Seagate Technology
10323 West Reno (West Dock)
Oklahoma City, OK 73127-9705
P.O. Box 12313
Oklahoma City, OK 73157-2313
Tel: 405-324-3070
Fax: 405-324-3794
gene_milligan@notes.seagate.com

10/31/2000
John Lohmeyer
T10 Chairman

Subject: Proposal to replace the TBDs for Fast 160 in SPI-4 and to winnow the options

Figure 50 - LVD receiver mask \leq Fast 80

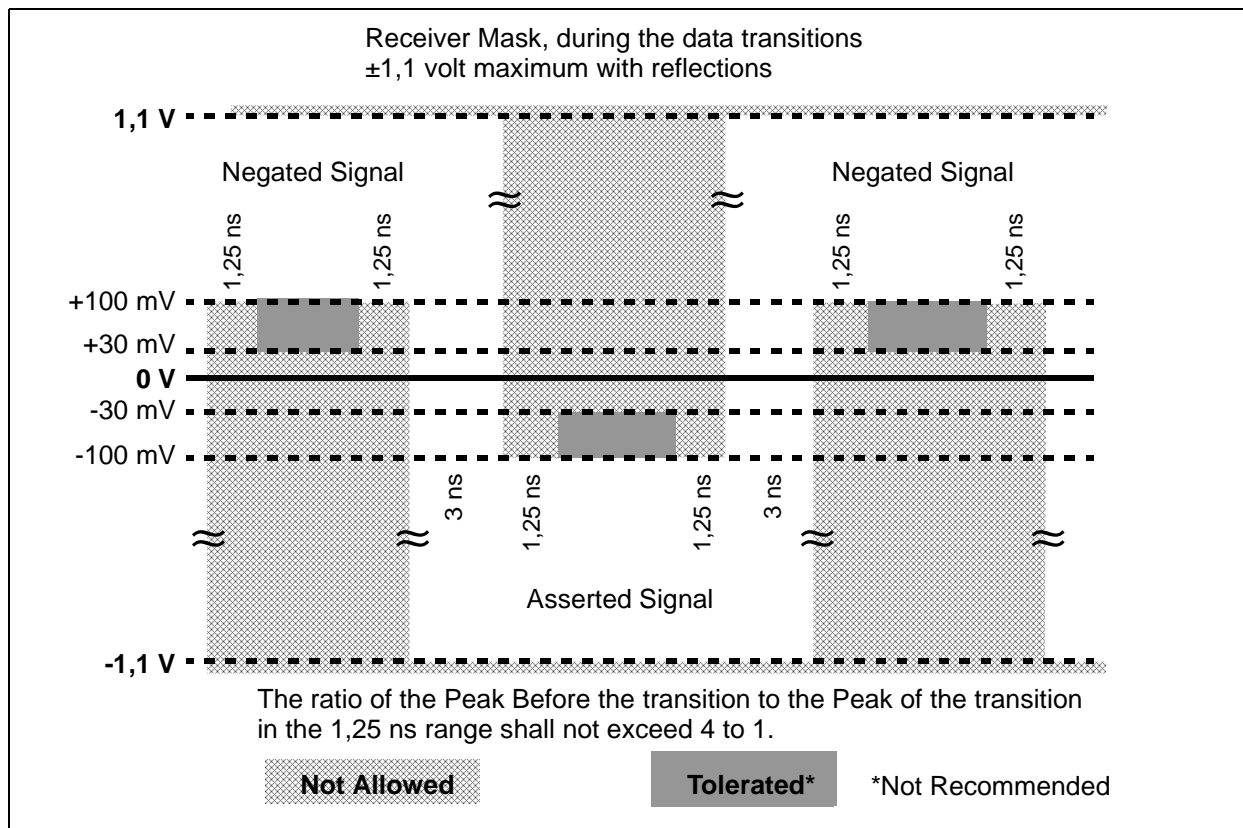
For Fast 80 the signal shall transition from -100 to +100 mV or +100 to -100 mV in 0 to 3 ns, the waveform between -100 and +100 mV is not otherwise specified. The absolute value of the signals shall remain above the 100 mV level for 1,25 ns at each end of the transition. The absolute value of the signals shall not drop below 30 mV except during the transitions (see 7.3.2).

Proposer's note: The above text has been moved from below Figure 49 to below Figure 50.

Figure 1 - LVD receiver mask 1 = Fast 160

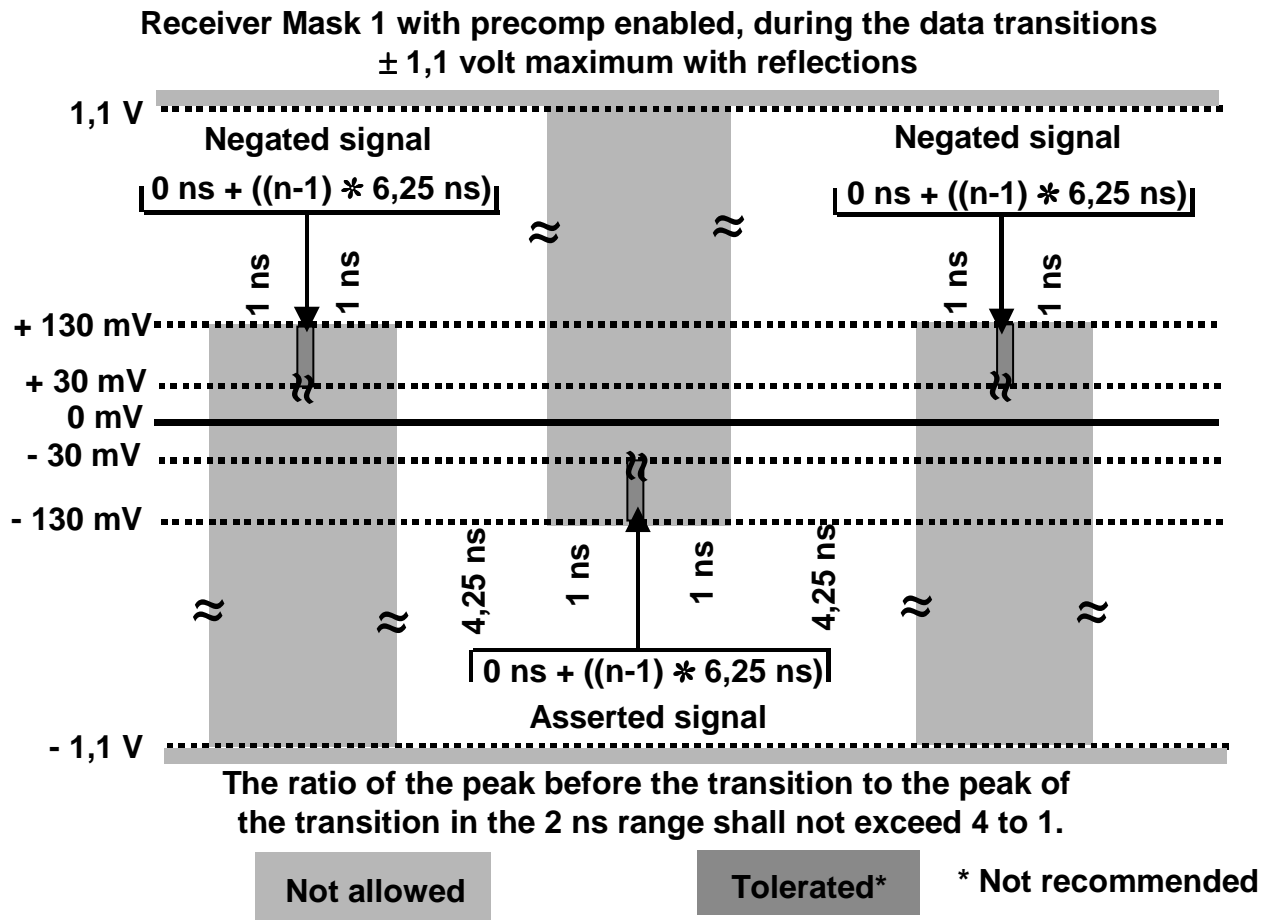
Proposer's note: This is Figure 51.

For Fast 160 the signal shall transition from -130 to +130 mV or +130 to -130 mV in 0 to 4,25 ns, the waveform between -130 and +130 mV is not otherwise specified. The absolute value of the signals shall remain above the 130 mV level for 1 ns at before and after each transition.

Figure 2 - LVD receiver mask 2 = Fast 160

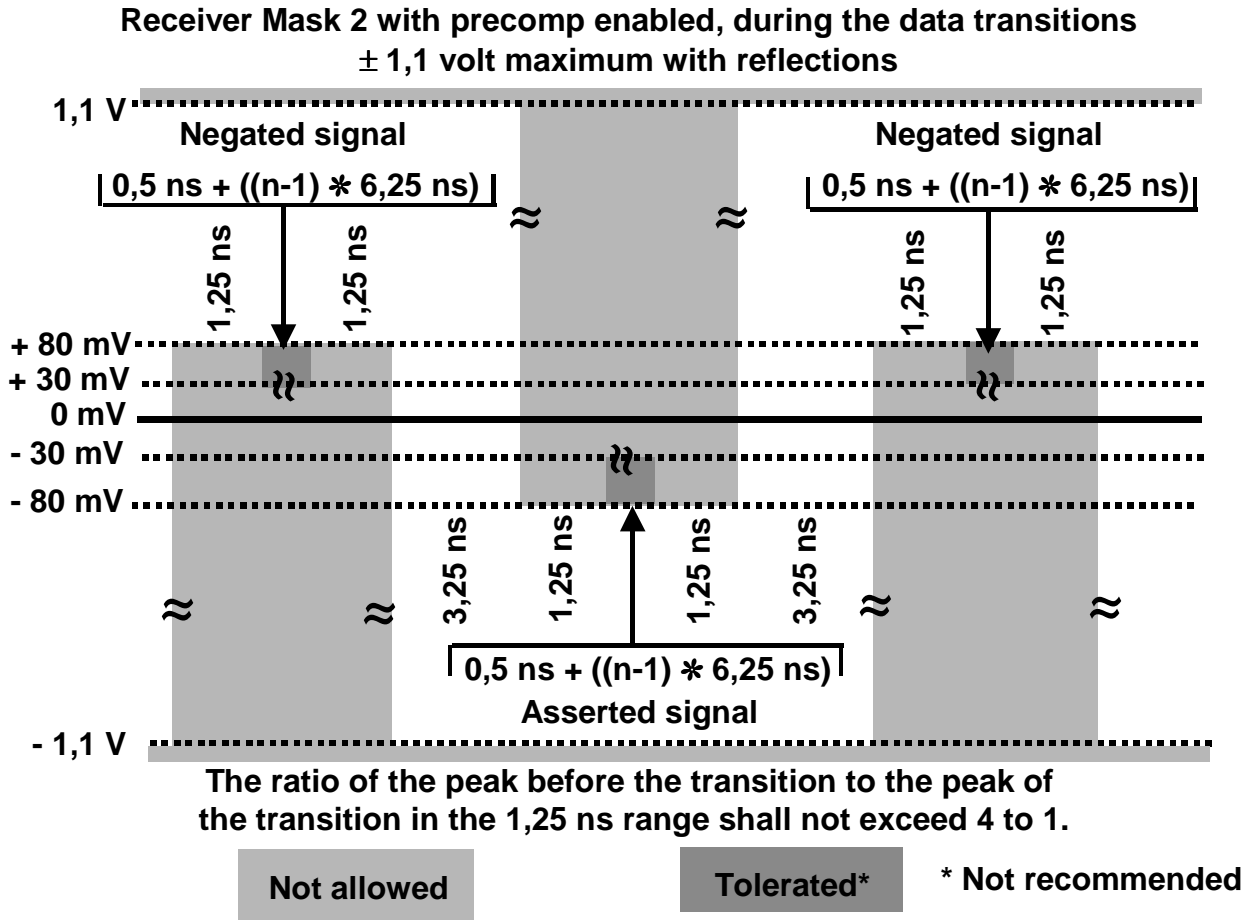
Editor's note: In preparing the changes from the working group meeting I noticed that somewhere along the line Mask 1 and Mask 2 were interchanged. Making the above number changes seemed to involve the fewest changes in revision 1 of this proposal. But for inclusion in SPI-4 the choice is somewhat arbitrary as long as the descriptive text matches the chosen order (mask number).

Proposer's note: This is Figure 52.

Alternatively, for Fast 160 the signal shall transition from - 80 to + 80 mV or + 80 to - 80 mV in 0 to 3,25 ns, the waveform between - 80 and + 80 mV is not otherwise specified. The absolute value of the signals shall remain above the 80 mV level for 1,25 ns before and after each transition. The absolute value of the signals shall not drop below 30 mV except during the transitions (see 7.3.2).

Figure A.1 - Domain for driver assertion and negation levels for Fast <160

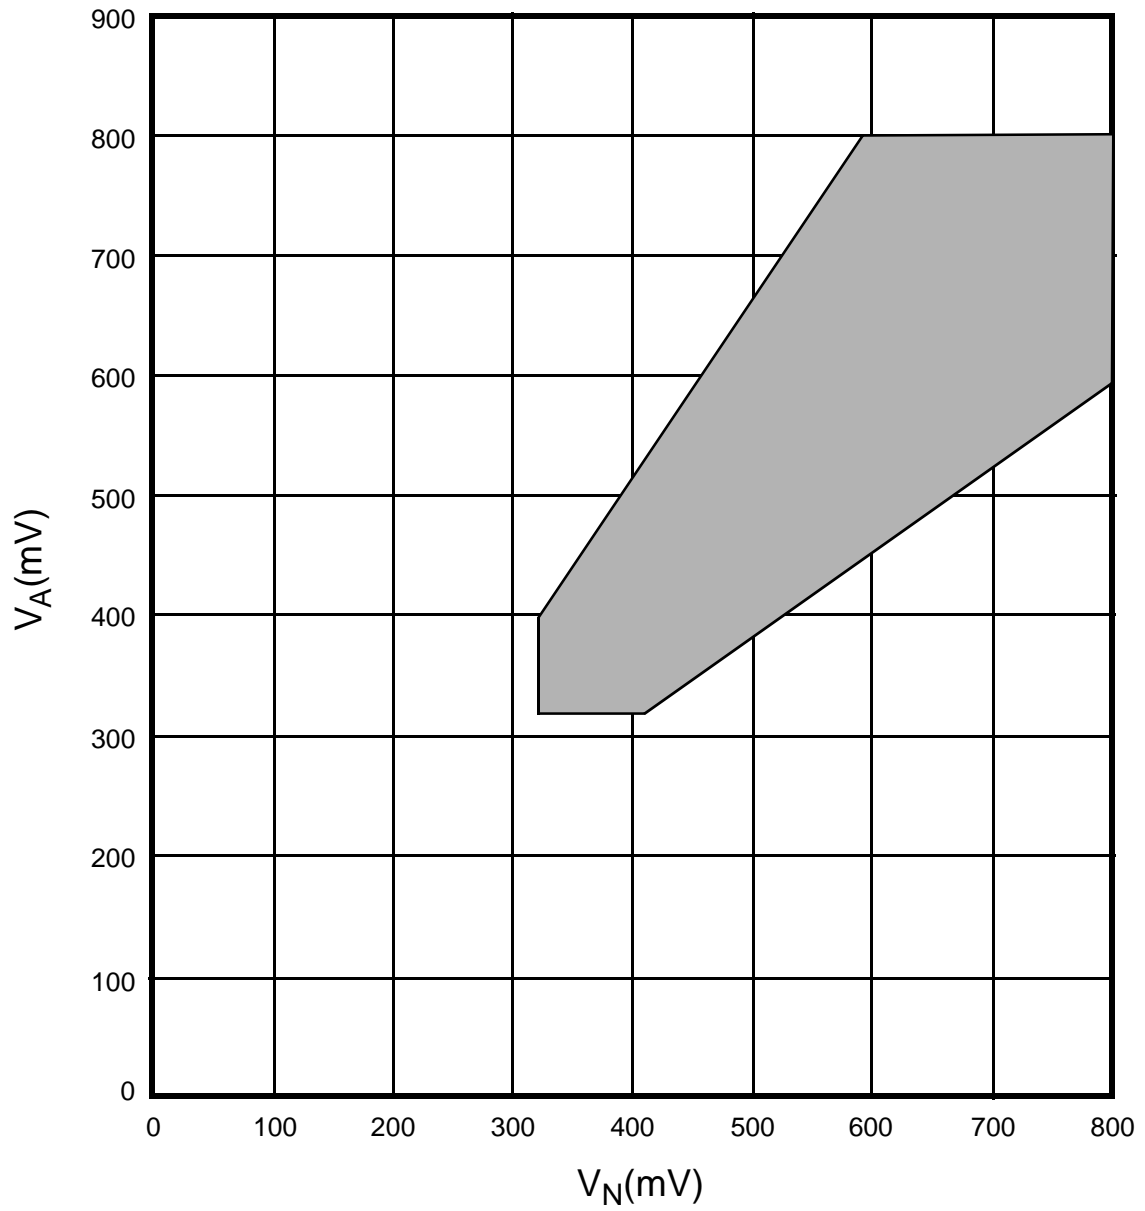
Proposer's note: The above figure should be Figure A.2.

Figure A.2 - Domain for driver assertion and negation levels for Fast 160

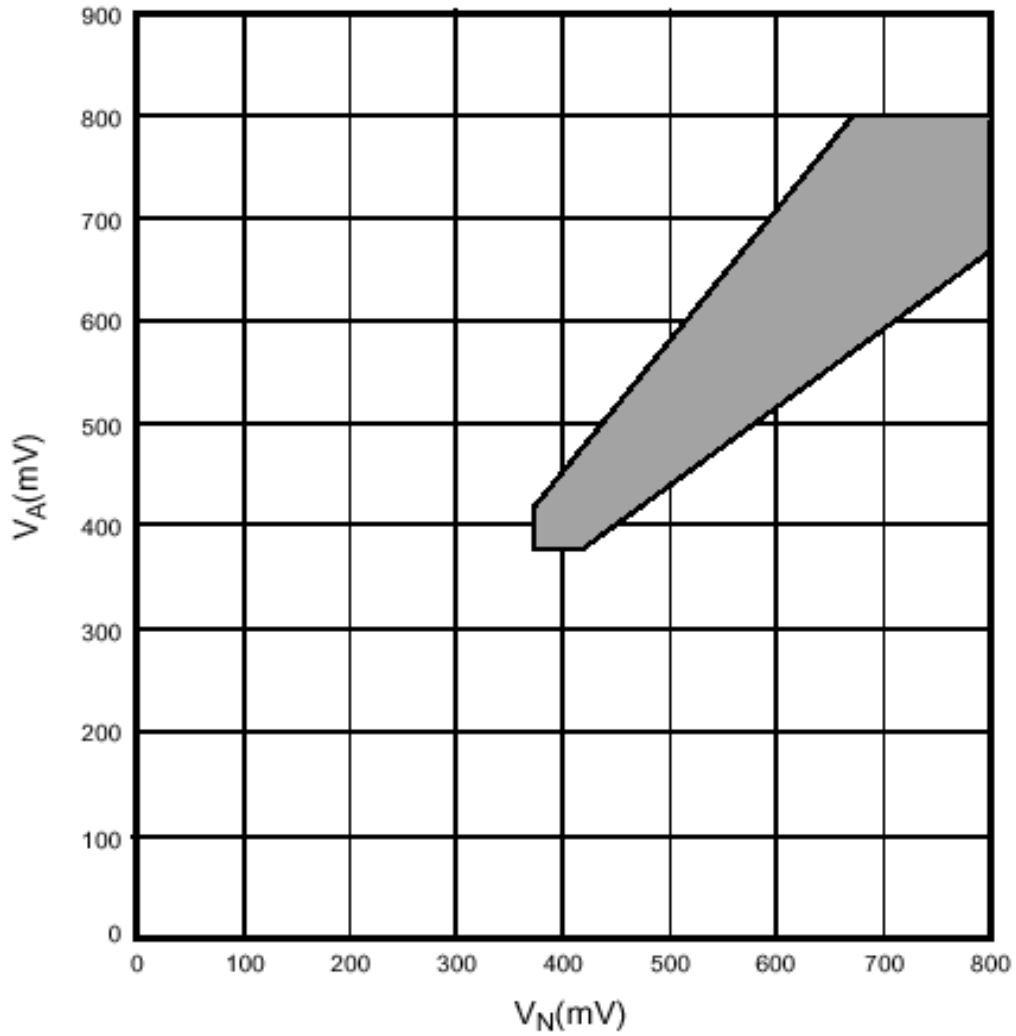
Proposer's note: The above figure should be Figure A.3.
